Planning & Zoning Commission Hybrid Meeting Agenda
September 17, 2025 7:00 P.M.
Putnam Municipal Complex
Room 113 First Floor
200 School Street
Putnam, CT 06260

Docket # 2025-06 Homes at School LLC - Special Permit-Multi-family-40 Residential
Units - 465 School Street

Subject: Revised Housing Project
465 School Street / Route 44
Town of Putnam

Subject: Revised Housing Project
465 School Street/ Route 44
Town of Putnam

DETAIL OF FENCE POST INSTALLATION USING SLEEVE-IT™ 1224R N.T.S.

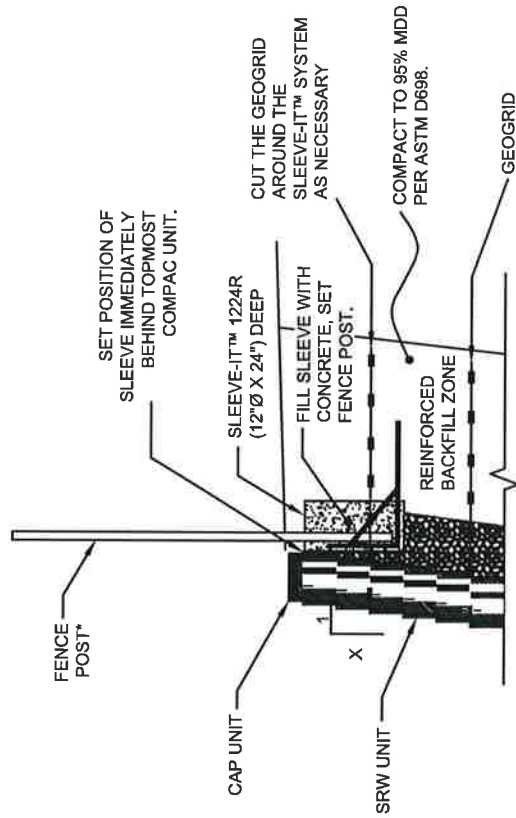
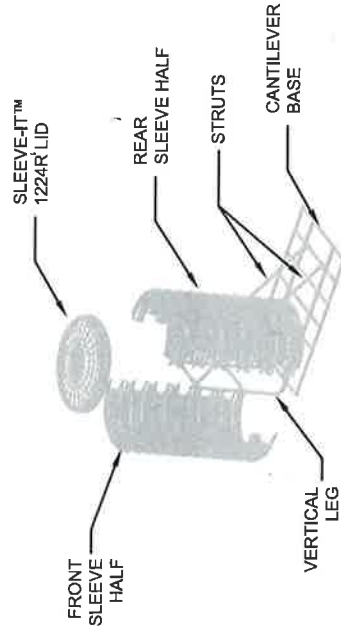
Provide a retaining wall and fence installation/construction detail.

A retaining wall detail sheet has been added to the site plans as sheet 10. Attached is a cut sheet for the Sleeve It product that is called for on sheet 10 of the plans, for installation of the fence adjacent to the walls.

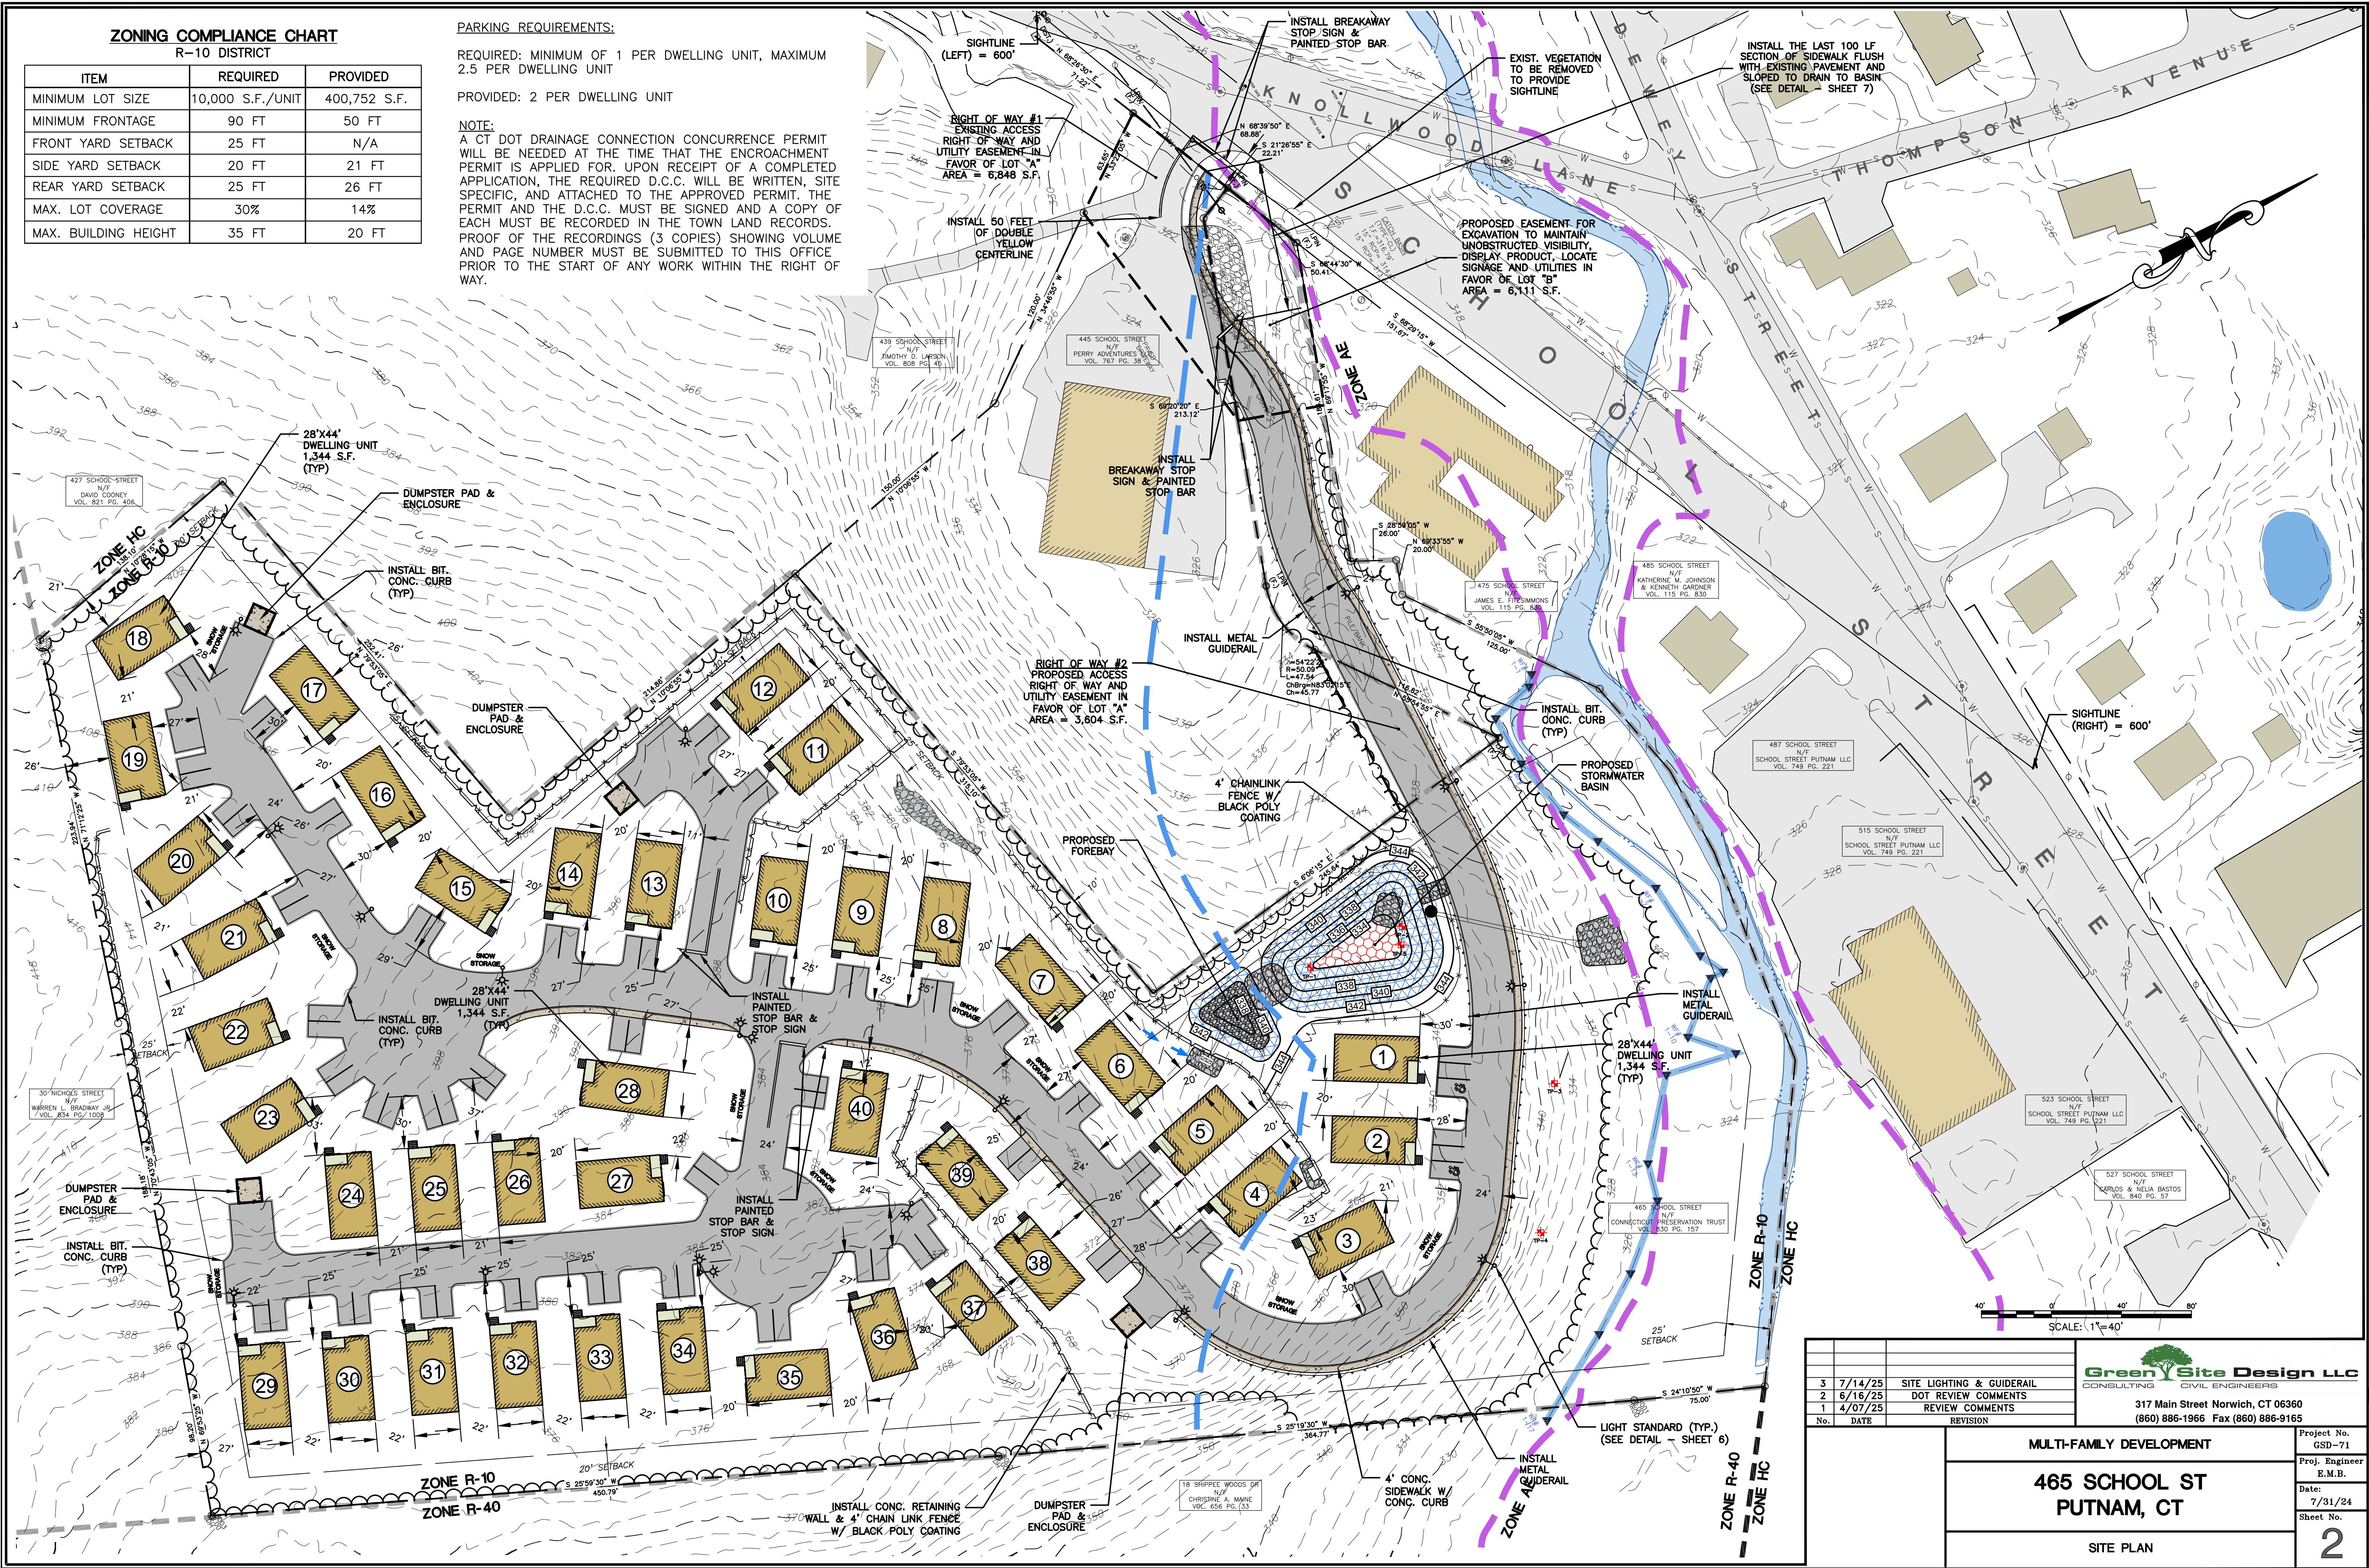
3. Please provide plans for the drive showing STOP sign, stop bar, and DYCL.

4. Revise plan set to show sightline demonstration.

5. Revise plan set to show breakaway signpost detail.

Noted on sheet 2 of the Site Plans

Added on sheet 2 of the Site Plans.

Shot in the field and shown on sheet 2.

Sheet 9 has been added to the plans with the DOT detail, and called out on sheet 2.

The owner of the property is Jim Wray, also owner of B & W Paving and Landscaping. They do professional snow plowing in the winter and will be plowing the site. I have labelled areas for snow storage on sheet 2 of the site plans.

LANDSCAPE PLAN

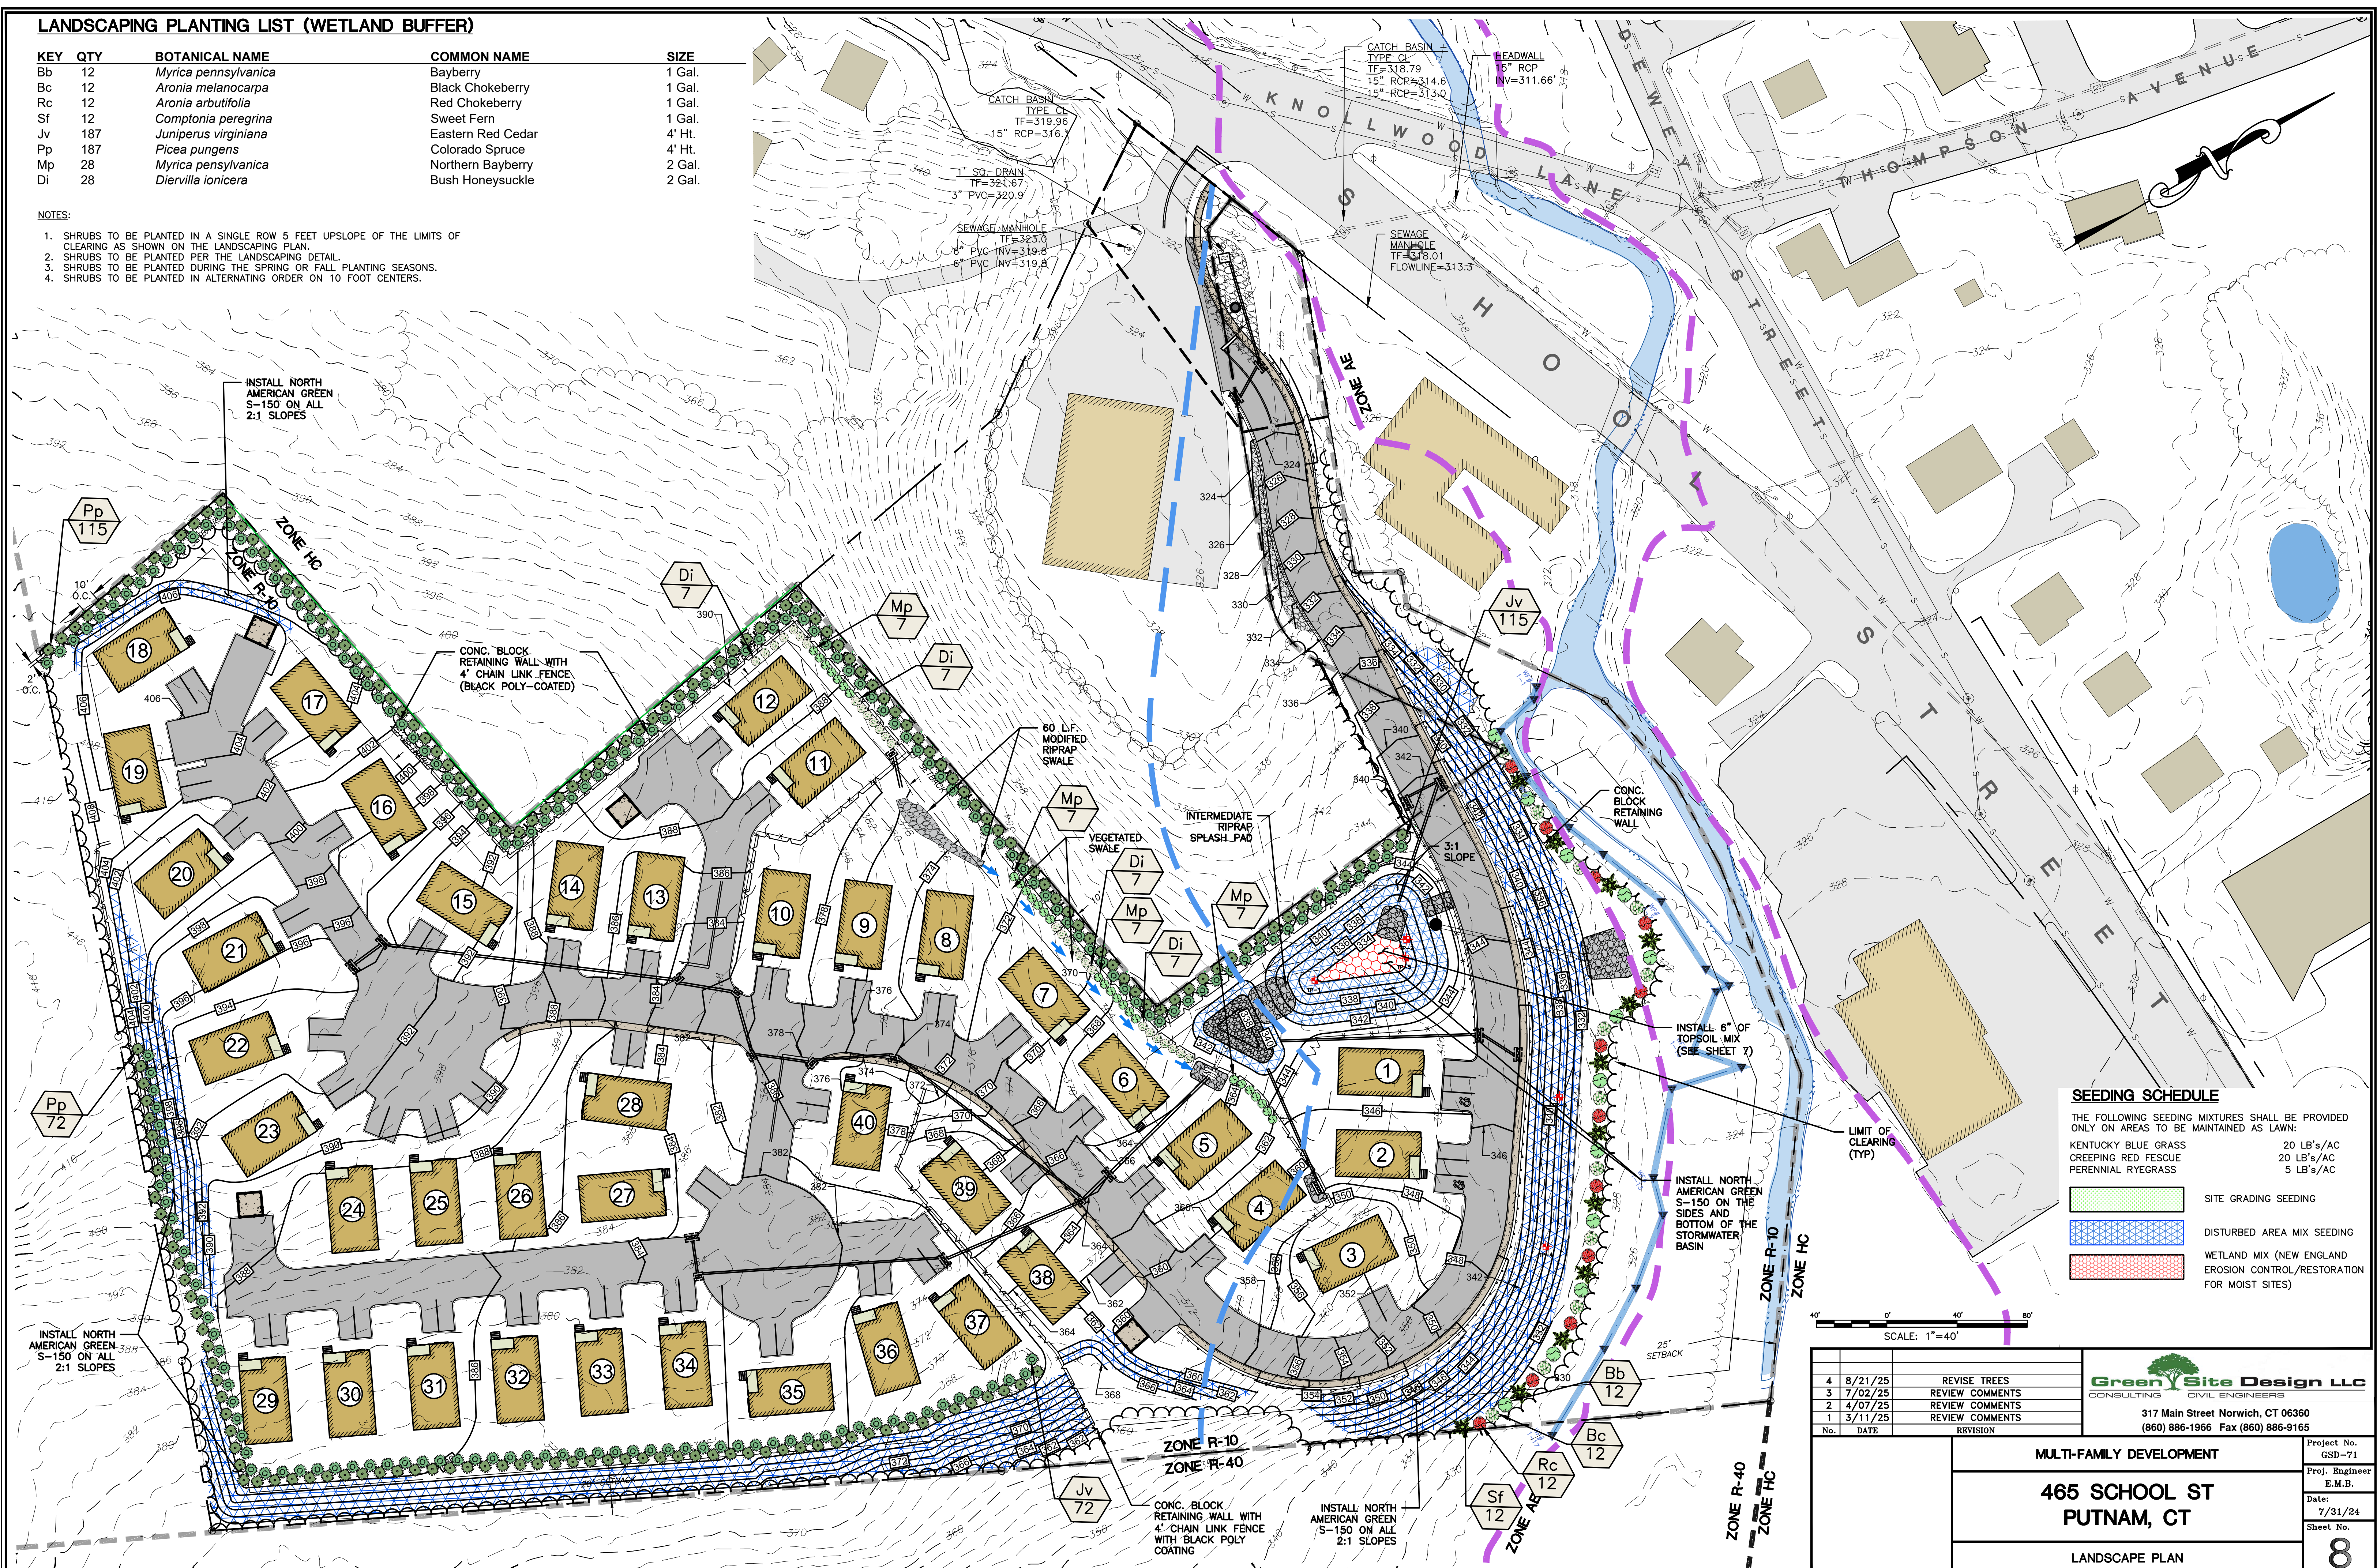
Plans depict landscaping on and beyond the property lines, drip edge/line should be on the subject property.

On the top of the retaining wall near Units 6-8 & 11-12 screening plantings to soften the view from the School St would be good.

The landscape plan, sheet 8, has been revised to address this comment.

Screening shrubs have been added at the top of the retaining walls.
